## Product Code Change

No. OERQC20130122-AY-006

### PCB Power Relays G2RL-2 series

Information of Product Code Change according to country origin change.

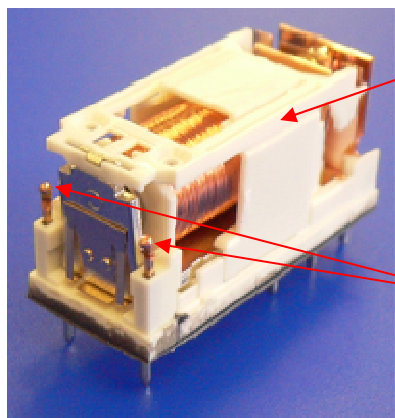
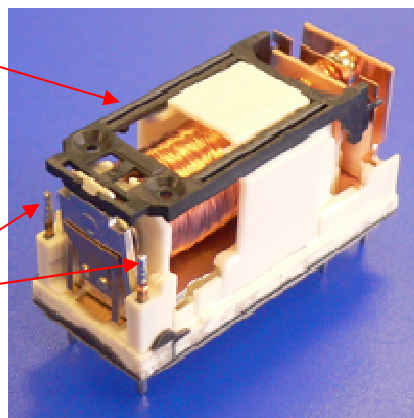
Before the change	After the change
<b>1. Name of production factory</b> OMRON RELAY & DEVICES Corporation (JAPAN)	<b>1. Name of production factory</b> OMRON MALAYSIA SDN. BHD. (MALAYSIA)
<b>2. Indication of Lot Number</b> ****Y1 (****:Production date Y1: Production factory code)	<b>2. Indication of Lot Number</b> ****W1 (****:Production date W1: Production factory code)
<b>3. Material color in the internal parts(CARD)</b> WHITE [Fig.1 item A]	<b>3. Material color in the internal parts(CARD)</b> BLACK [Fig.1 item A] (the same material as Japan)
<b>4. Connection way between magnet wire and coil terminal</b> WELD [Fig.1 item B]	<b>4. Connection way between magnet wire and coil terminal</b> SOLDER (Pb free) [Fig.1 item B]

※Above picture is example of G2RL-1 series, Changes of G2RL-2 series is same as G2RL-1 series.

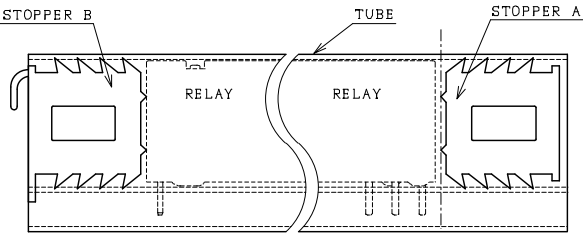
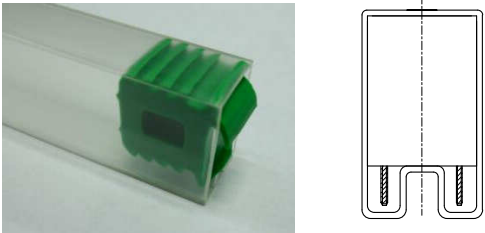
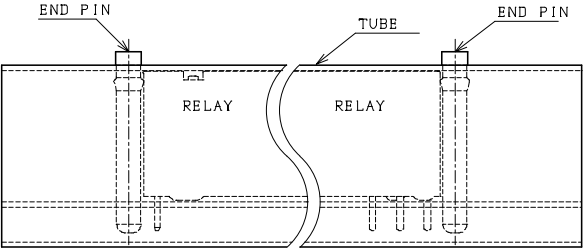
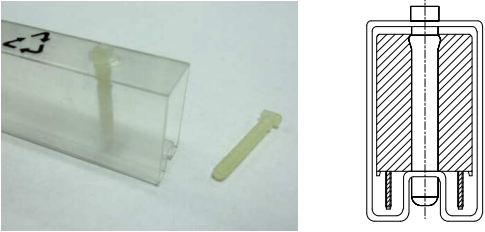
Before the change	After the change
<p><b>5. Packing (stopper of sticks)</b> Packing Tube: 20pcs. Relays/ Tube</p>   <p><b>6. Material of sticks</b> ABS</p> <p><b>7. Display of the Country Origin</b> Product: JAPAN Package: MADE IN JAPAN</p>	<p><b>5. Packing (stopper of sticks)</b> Packing Tube: 20pcs. Relays/ Tube</p>   <p><b>6. Material of sticks</b> PS-HI</p> <p><b>7. Display of the Country Origin</b> Product: <b>MALAYSIA</b> Package: MADE IN <b>MALAYSIA</b></p>
